**ADDENDUM NO. 2**

**Sedgwick County Project: Drainage Channel Improvements from 87<sup>th</sup> to 79<sup>th</sup> Street South (D21)**

**Date: June 15, 2023**

**DITCH LINING**

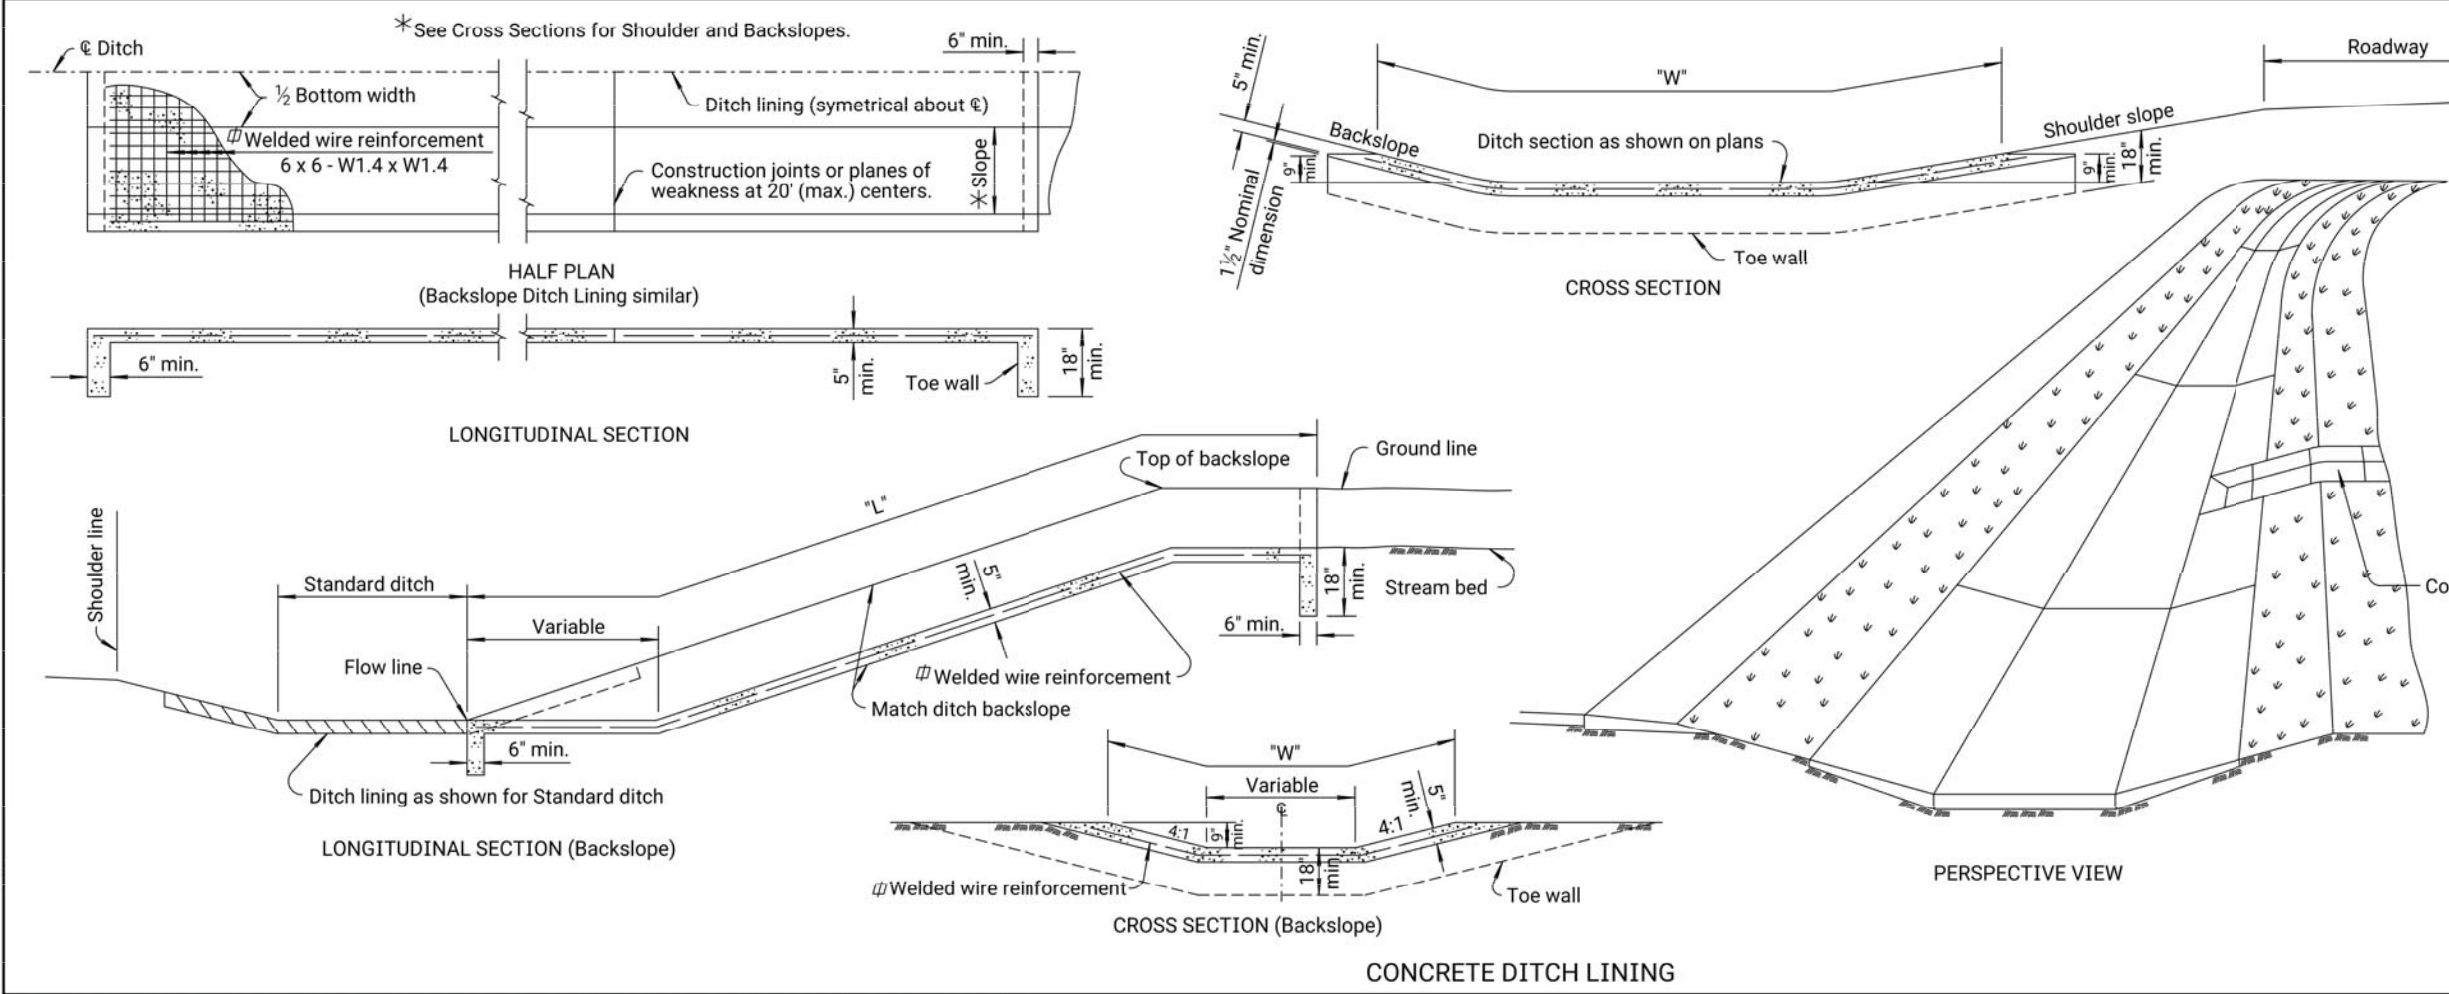
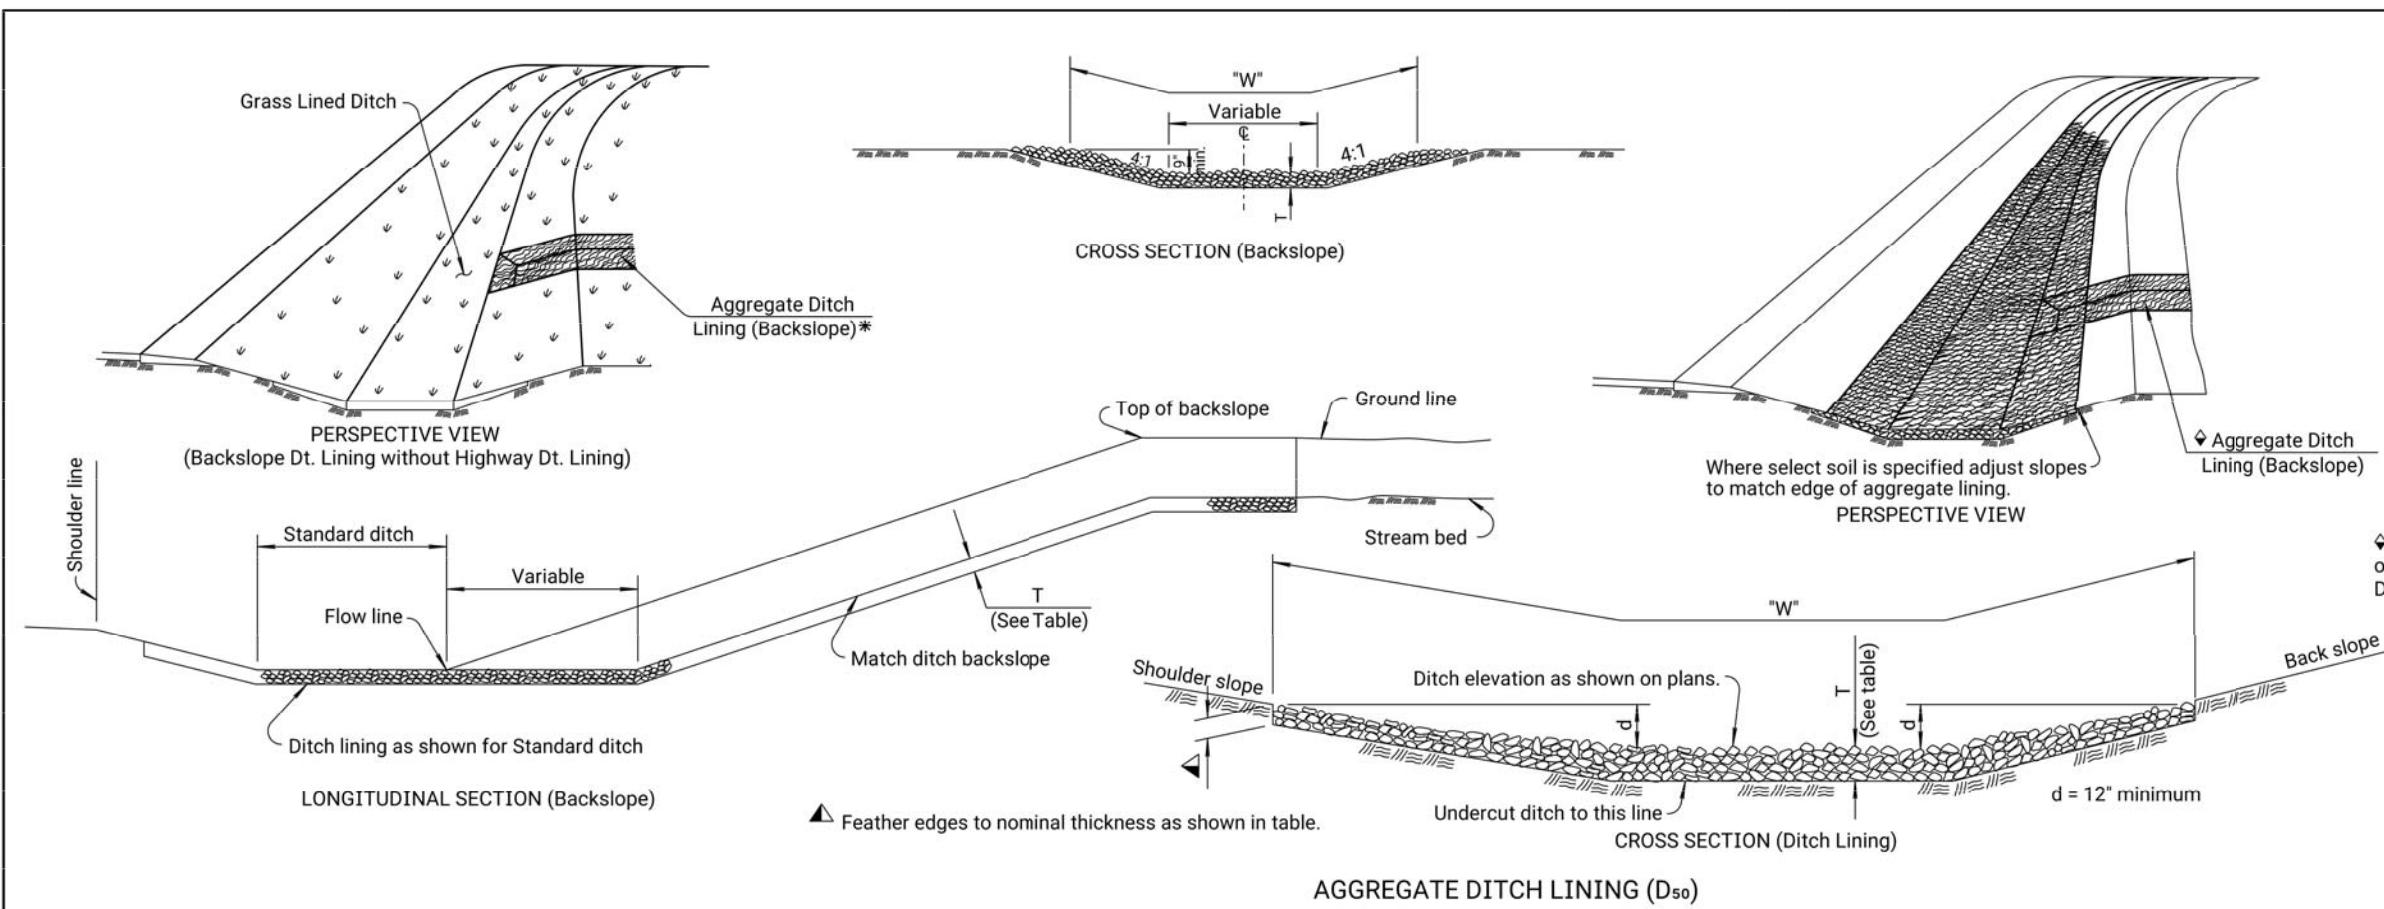
- Replace Plan Sheet 9 with Plan Sheet 9R
  - Replace the General Note “concrete grade shall be 3.0” with “concrete grade 4.0 AE per KDOT specifications shall be used in Concrete Ditch Lining.”
  - Remove from the General Note the option to use macro fiber reinforcement.

▲ 06-15-23 Concrete Grade Type and removal of fiber reinforcement option.

**GENERAL NOTE**  
 Concrete Grade 4.0 AE shall be used in Concrete Ditch Lining.  
 Welded wire reinforcement shall be of the electrically welded square mesh type with No. W1.4 wires spaced at 6" ctrs. each way.  
 Reinforcement as shown is included in the unit price bid for "Concrete Ditch Lining".  
 Measurements of Concrete Ditch Lining shall be in sq. yds. of outside surface area. Add 1'-6" times "W" for each toewall.  
 The exact location and dimensions may be adjusted, if required, by the Engineer at the time of construction.  
 Longitudinal construction joints may be constructed at the Contractor's option.  
~~Welded wire can be substituted with macro fiber reinforcement. See Standard Specifications for macro fiber and application rate requirements.~~
